777

Service Bulletin

Number: 777-53A0075
Original Issue: January 14, 2015
Revision 1: December 14, 2015
ATA System: 5380

SUBJECT: FUSELAGE - Section 48 - Station 2370 Pivot Bulkhead Forward Outer Chord -
Inspection and Repair

FIGURE 7: LEFT SIDE - STA 2370 PIVOT BULKHEAD FORWARD OUTER CHORD - PART REMOVAL (SHEET 1 OF 10)

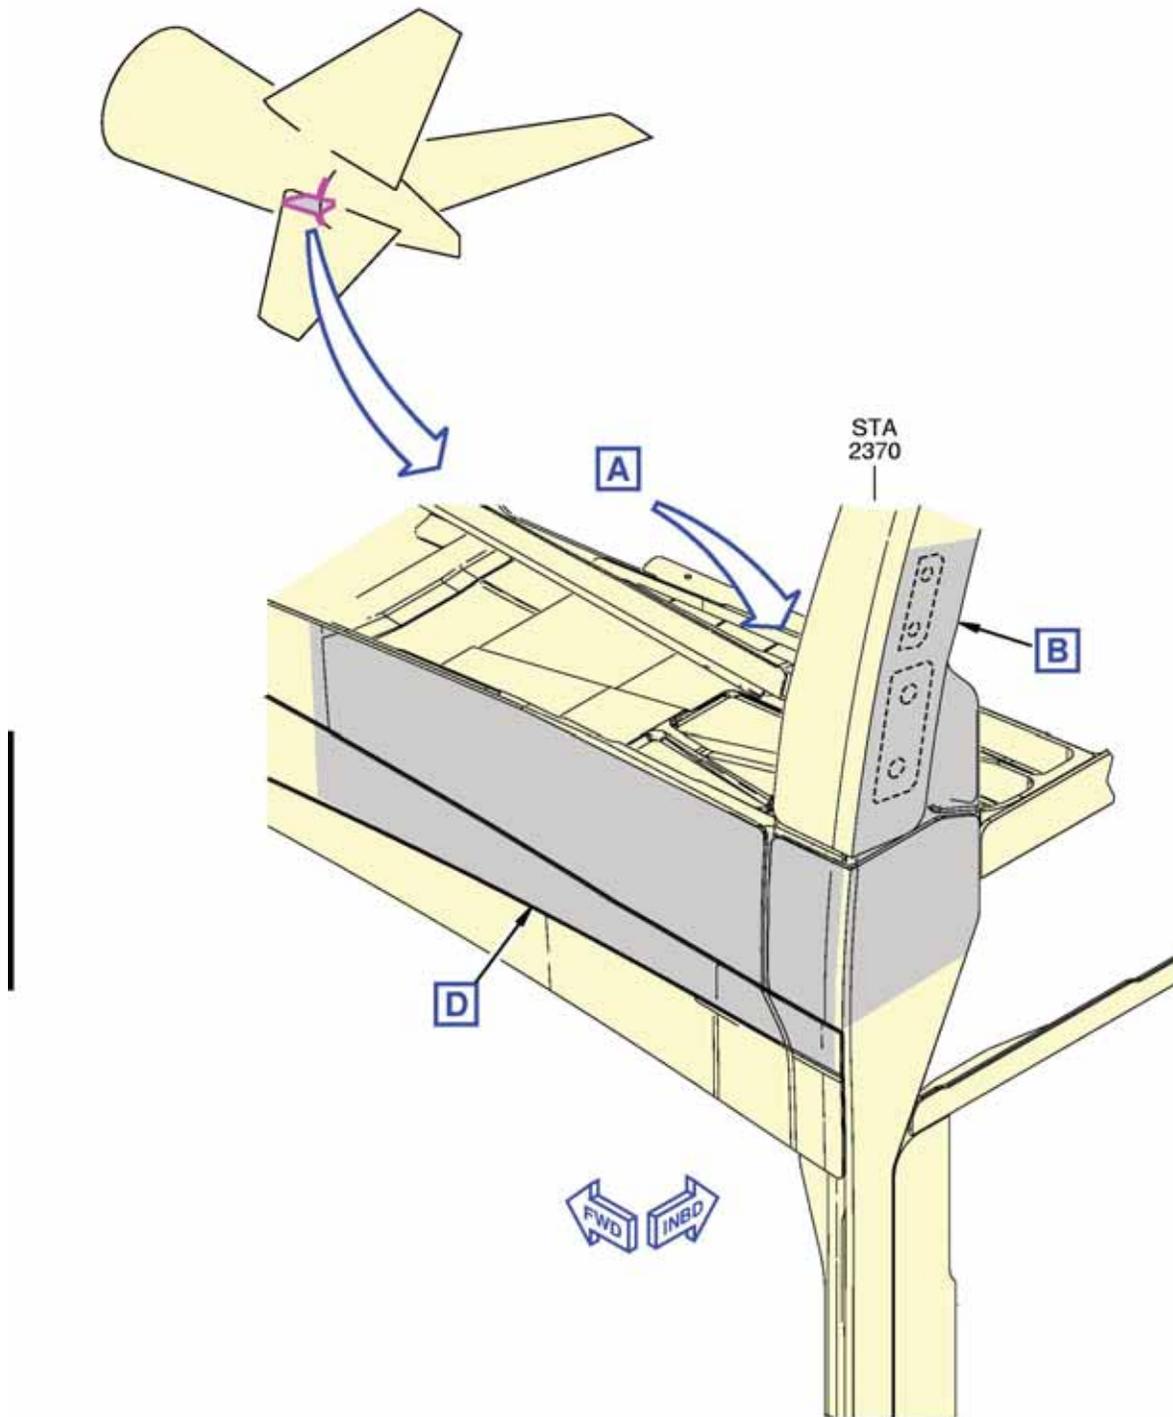
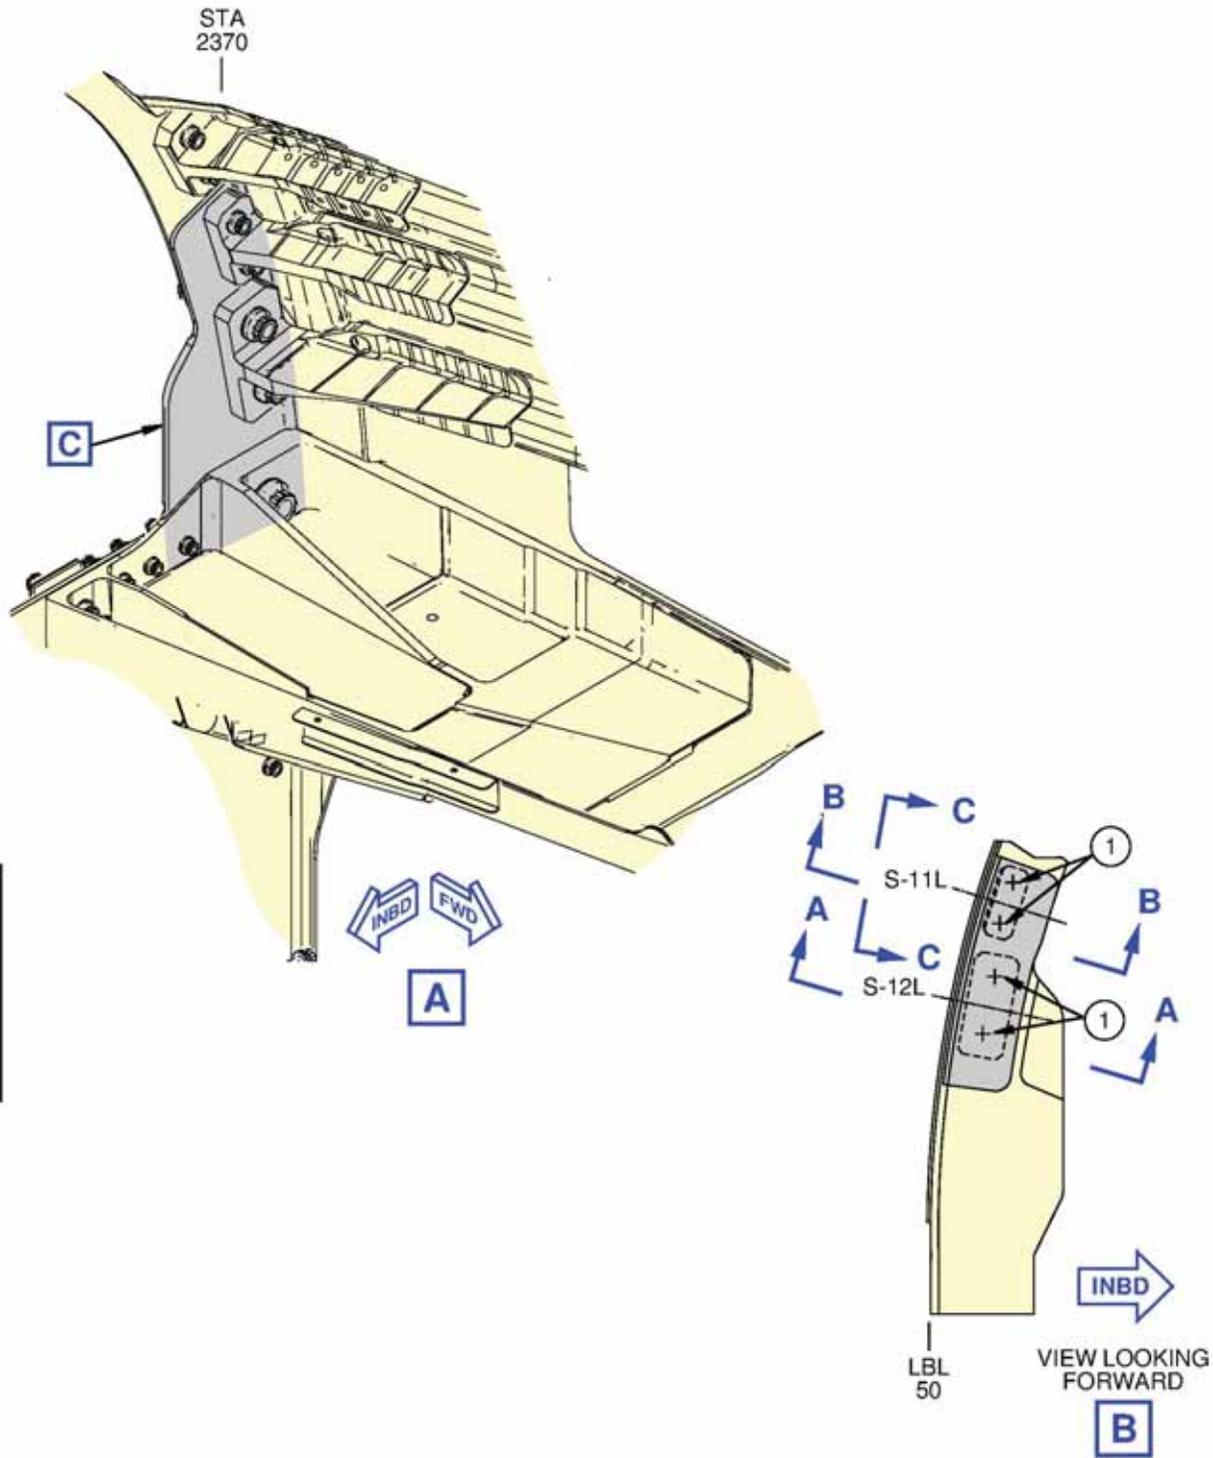
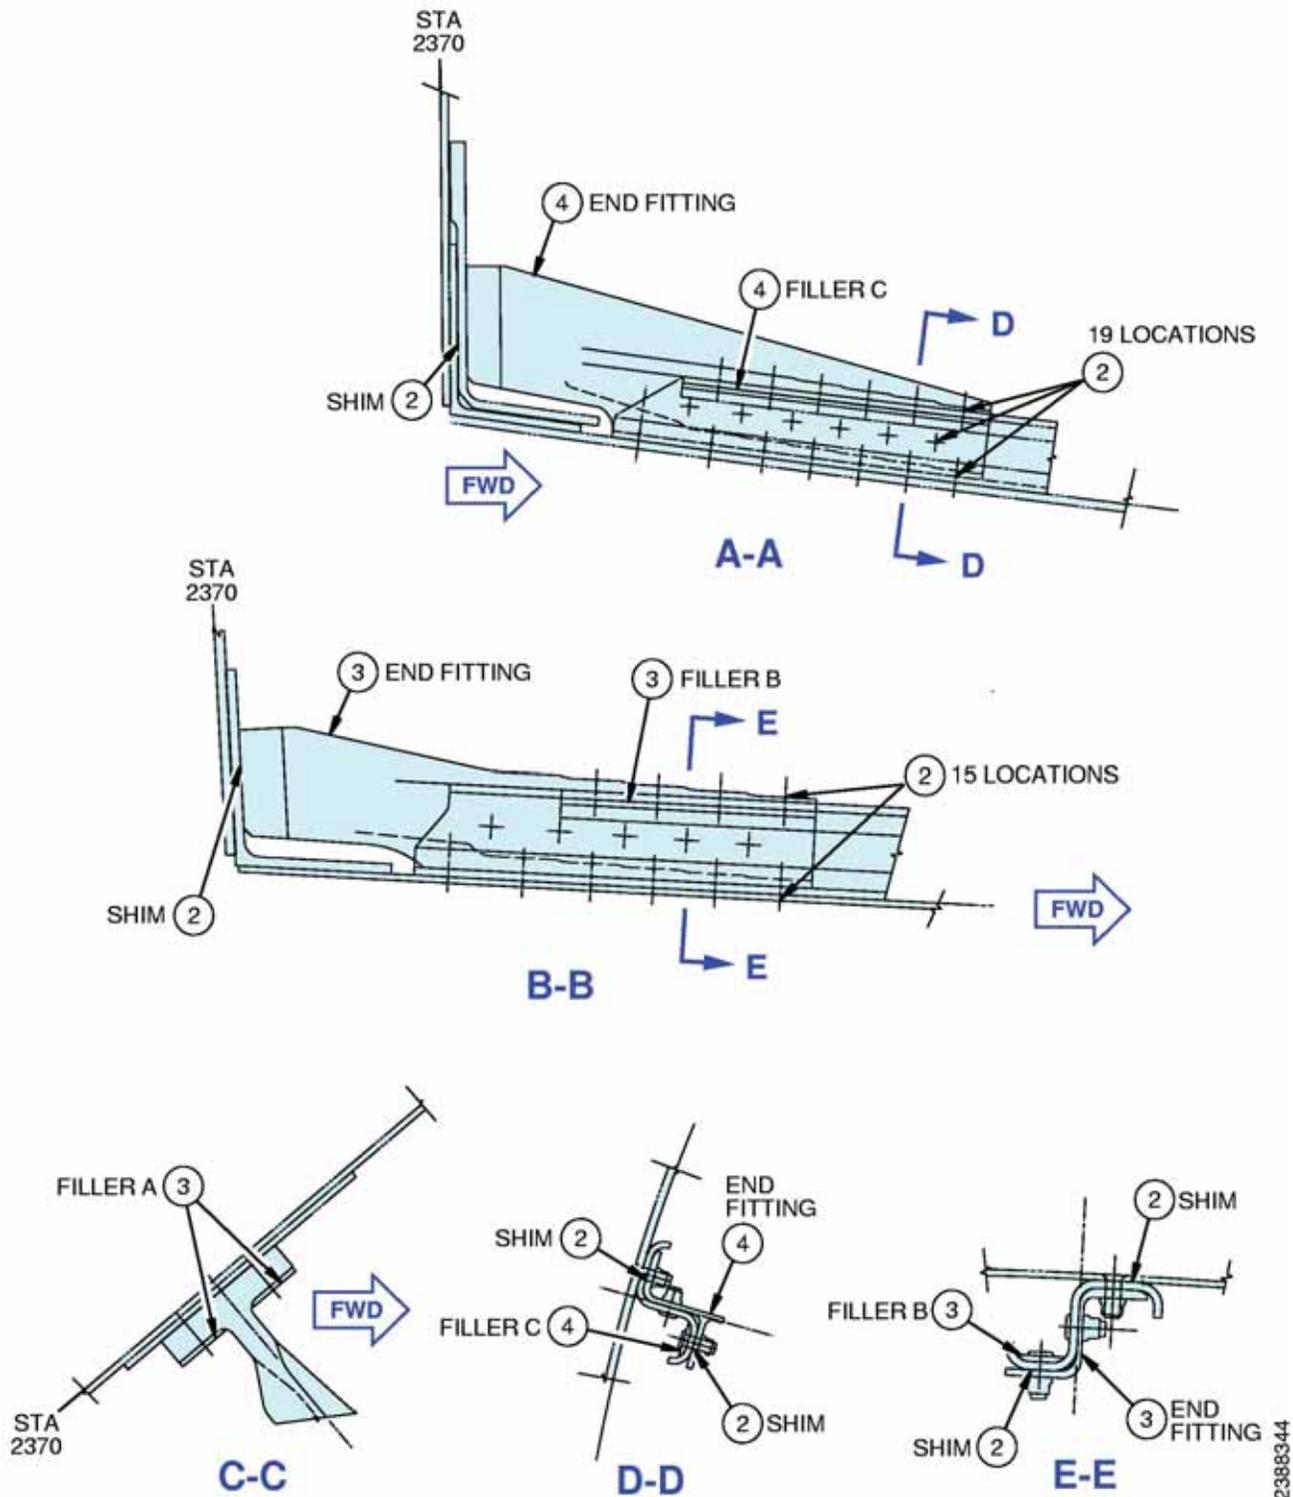
20. In Figure 7, Figure 8, Figure 9 and Figure 10, revised the illustrations and the step table.
21. In Figure 11, Figure 12, Figure 13 and Figure 14, revised the illustrations.
